#### **Appendix A**

**Consultation Records**

Sandwich South Master Servicing Plan

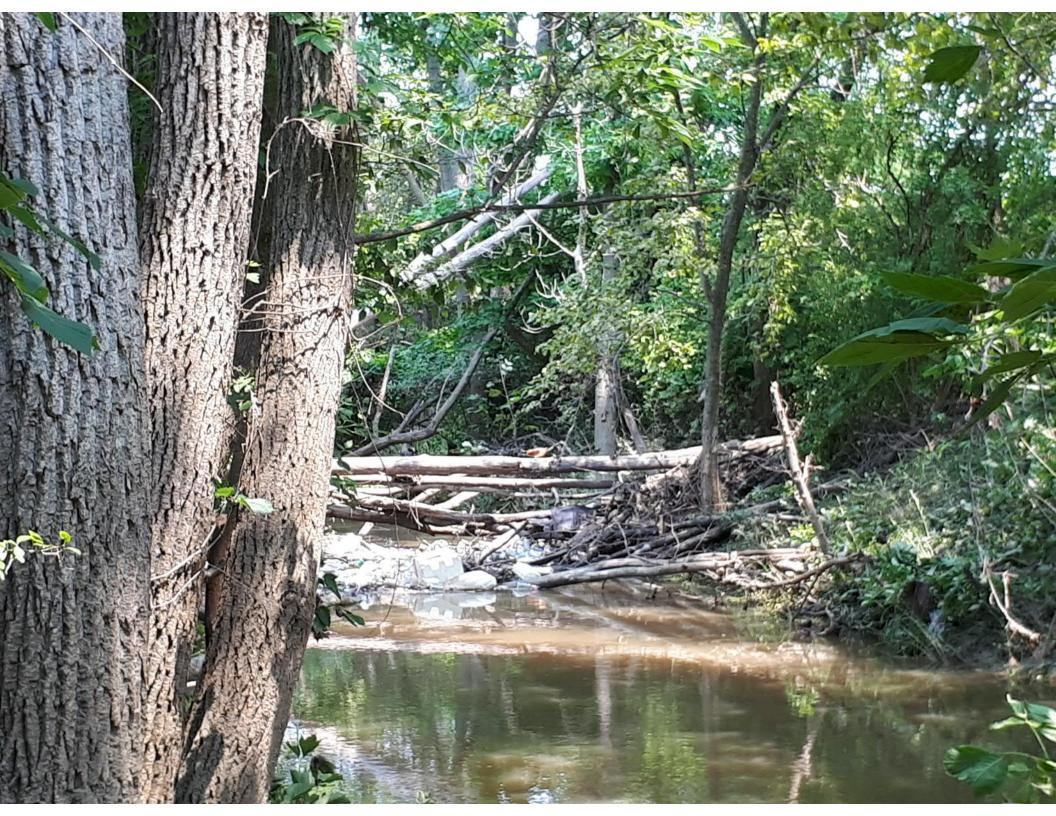
- Figure 3 -identifies Stormwater Management Strategy with an area of Open Space/Stormwater Management, which in the true sense requires Open Space to be marked in another colour since at no time has the two been combined in any presentations or discussions or the fact that your actual outline in the presentation material to have used the word "Open Space" as well as your statement and reference to be combined into Natural Heritage Areas in the NOTE section, which requires further discussion and not addressed at our meeting of Sept. 7, 2021, or for Figure # 4 and # 5.

- -Figure # 4 -also has a new Identification area described as Open Space/ Stormwater Management Corridor, which does not make sense and requires further explanation and correction.

- Figure # 5 also has a land identification not present or available for review by the public to make a comment or propose a question on a colour ID that refers to Natural Heritage and then shows OpenSpace/ Stormwater Management Corridor, or a colour ID referencing Open Space/Stormwater Management Corridor.
